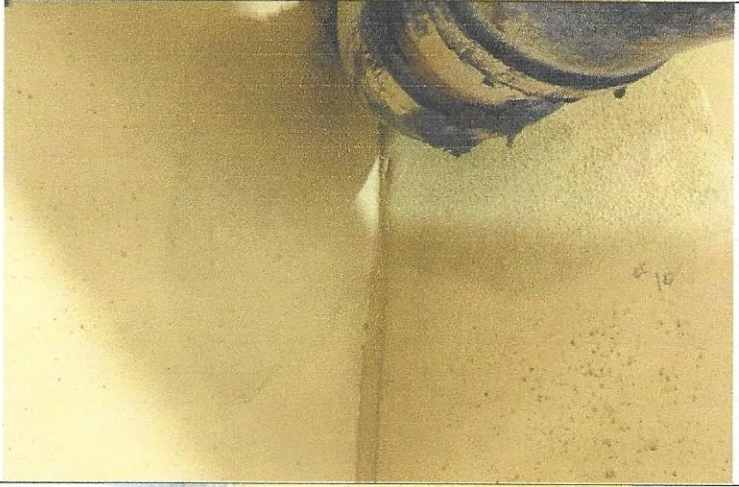
<p>Photo No. 13</p> <p>Location: Third Floor Walkway</p> <p>Comments:</p> <p>This repair area's finish was uneven and done poorly. This needs to be redone.</p> <p>Re-inspection required: <input checked="" type="checkbox"/> yes <input type="checkbox"/> no</p>	
<p>Photo No. 14</p> <p>Location: Pump Room</p> <p>Comments:</p> <p>These areas were repaired and completed.</p> <p>Re-inspection required: <input type="checkbox"/> yes <input checked="" type="checkbox"/> no</p>	
<p>Photo No. 15</p> <p>Location: Pump Room</p> <p>Comments:</p> <p>The contractor provided photos for the repair adjustments noted in the previous report. These areas were reviewed and approved.</p> <p>These areas were repaired and completed.</p> <p>Re-inspection required: <input type="checkbox"/> yes <input checked="" type="checkbox"/> no</p>

Photo No. 10

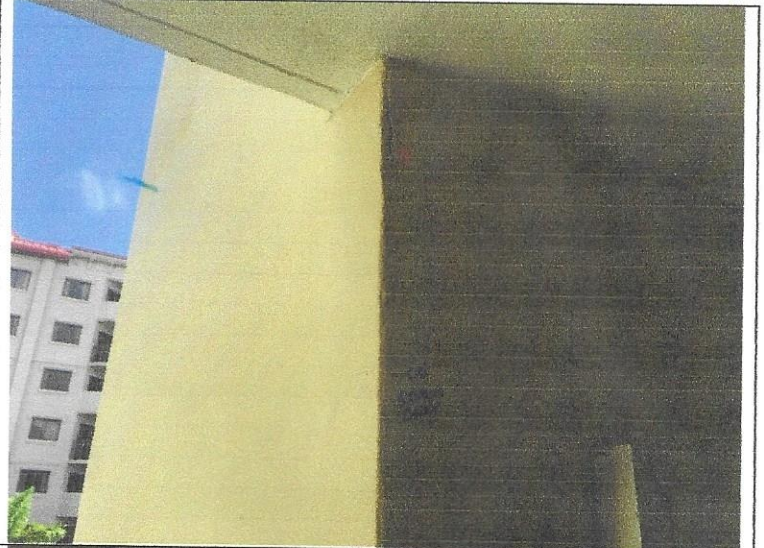
The sixth-floor repair area in front of unit 601 needs to still be repaired.

Photo No. 12

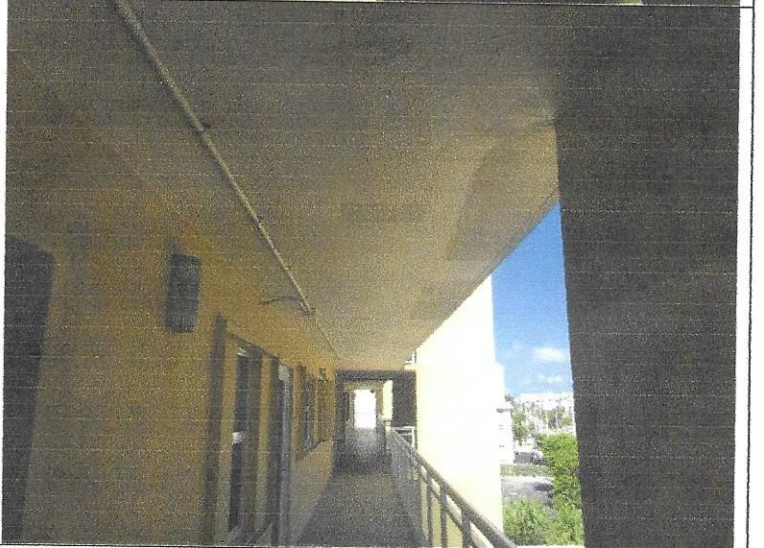
This repair area's finish was uneven and done poorly. This needs to be redone.
